United States Nuclear Regulatory Commission Official Hearing Exhibit	
POWERTECH USA, INC. (Dewey-Burdock In Situ Uranium Recovery Facility)	
	ASLBP #: 10-898-02-MLA-BD01
	Docket #: 04009075
	Exhibit #: INT-021A-00-BD01
	Admitted: 8/19/2014
	Rejected:
Other:	Identified: 8/19/2014 Withdrawn: Stricken:

**Mine Unit 1 Restoration Report****Crow Butte Uranium Project****January 10, 2000****United States Nuclear Regulatory Commission  
Source Materials License SUA-1534**

**Submitted To:** US Nuclear Regulatory Commission  
Office of Nuclear Material Safety and Safeguards  
11545 Rockville Pike  
Rockville, Maryland 20850

FIGURE 1. Unit 1 Radium-226 Measurements

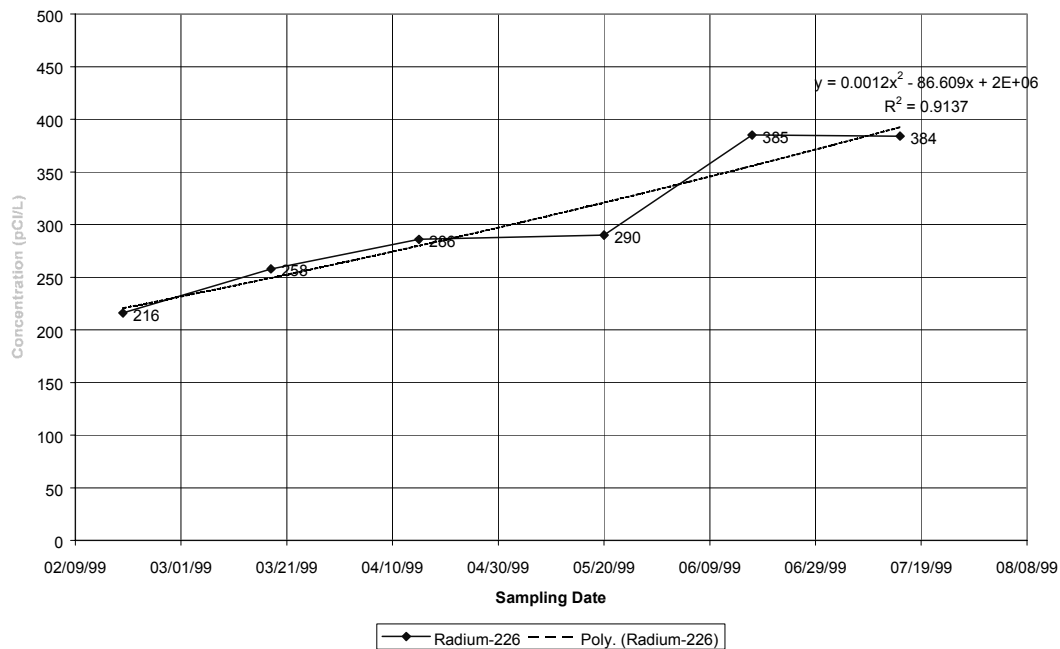
1. **Finding:** Staff’s analysis indicates that concentrations of ammonium, iron, radium-226, selenium, total dissolved solids, and uranium show strongly increasing concentration trends over the stability monitoring period. These trends indicate a reasonable likelihood that license limits would be exceeded in the near future. Other constituents appear to have reached stability, or exhibit such a weakly increasing trend that stability is not a concern. Figures 1, and 2, provide examples of strongly increasing concentration trends in the monitored data during the stability monitoring period. These increasing trends represent a particular concern when a constituent has been restored to the secondary restoration goal, as these two examples were. The secondary restoration standards are greater than the pre-operational baseline concentrations, but are considered protective of the adjacent aquifer beyond the limits of the U.S. EPA designated aquifer exemption boundary. Increasing trends that indicate a potential future exceedance of baseline limits do not represent an immediate concern, since the secondary limits are higher than the baseline limits and are considered protective. Figures 3, and 4, illustrate two constituents that appear to have stabilized during the stability monitoring period. Although Figure 3, shows an increasing trend, this trend is not significant. Figure 4 shows a strongly increasing trend in the early measurements, but the trend dissipated by the time the later data were collected.

1. The licensee's request for Unit 1 wellfield restoration approval should be denied.
2. Decommissioning of Unit 1 should not proceed at this time.
3. Stabilization ground-water monitoring in Unit 1 should be restarted immediately at the monitoring locations described in the January 10, 2000, Restoration Report. The ground-water should be sampled and analyzed for the constituents listed in License Condition 10.3B, SUA-1534, on a schedule of at least 14 days apart. The wellfield restoration shall be considered stable if four consecutive sampling episodes show no strongly increasing concentration trends for all monitored constituents, on a wellfield average, as described in Section 6.1.3, "Standard Review Plan for *In Situ* Leach Uranium Extraction License Applications," NUREG-1569.
